Access Compliance Report

Public Rights-of-Way

Intersection ID: 10024753	Main Street: DEER_SPRING_LN	Cross Street: N/A	Location: SE
ADA ID: 5C4D3995E6DB	Ramp Type: BlendTrans2	Initial Pass/Fail: Pass	Overall Compliance: No
Severity Score: 10.25			
Codes/Mitigation Info/Possible Solution		Field Measurements/Component Compliance

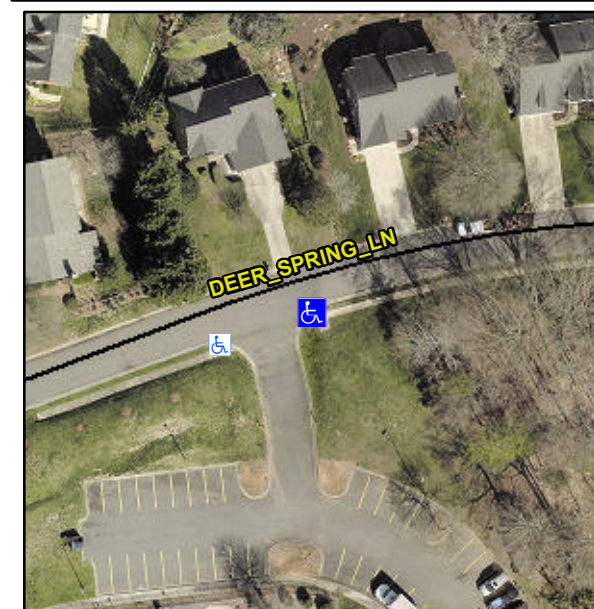
Not Found, R304.5.3, R305

Compliance	Description	Data	Compliance	Description	Data
N/A	Ramp Length (in)	48.0	Yes	BlendTrans Slope (%)	4.2
Yes	Ramp Width (in)	49.0	No	BlendTrans XSlope (%)	3.8
N/A	Flare Type LT	Sloped	N/A	Flare Type RT	Sloped
N/A	Flare Slope LT (%)	N/A	N/A	Flare Slope RT (%)	N/A
N/A	Flare Traversable LT?	No	N/A	Flare Traversable RT?	No
N/A	Landing Length (in)	N/A	No	DWS Provided?	No
N/A	Landing Width (in)	N/A	N/A	DWS Contrast?	No
N/A	Landing Slope (%)	N/A	N/A	DWS Length (in)	N/A
N/A	Landing X Slope (%)	N/A	N/A	DWS Full Width?	No
N/A	Landing Curb? (Y/N)	No	N/A	DWS Offset (in)	N/A
N/A	Shared Landing?	No			
Yes	Gutter Ponding?	No	Yes	Gutter Slope (%)	0.7
Yes	Gutter Lip Ht (in)	0.0	No	Gutter X Slope (%)	5.6
N/A	Painted X Walk1?	No	N/A	Painted X Walk2?	No
	X Walk 1 Direction	To N		X Walk 2 Direction	To SW
	X Walk 1 Width (in)	N/A		X Walk 2 Width (in)	N/A
	X Walk 1 Slope (%)	5.6		X Walk 2 Slope (%)	8.5
	X Walk 1 X Slope (%)	6.1		X Walk 2 X Slope (%)	2.5

N/A	Ramp inside XWalk1?	N/A	N/A	Ramp inside XWalk2?	N/A
	Road Slope (%)	2.6		Clear Space?	Yes
	Road X Slope (%)	9.1	N/A	Clear Space to XWalk (in)	N/A
Yes	Any Obstructions?	No	Yes	Storm Grate/Utility Hazard?	No
	Obstruction Type			Storm Grate/Utility Type	
		N/A			N/A
			Yes	Surface Condition? (G/P)	Good
			No	Curb Slope (%)	7.8

Remove & Replace Curb Ramp With Two New Directional Ramps or Equivalent. Remove & Replace Gutter.
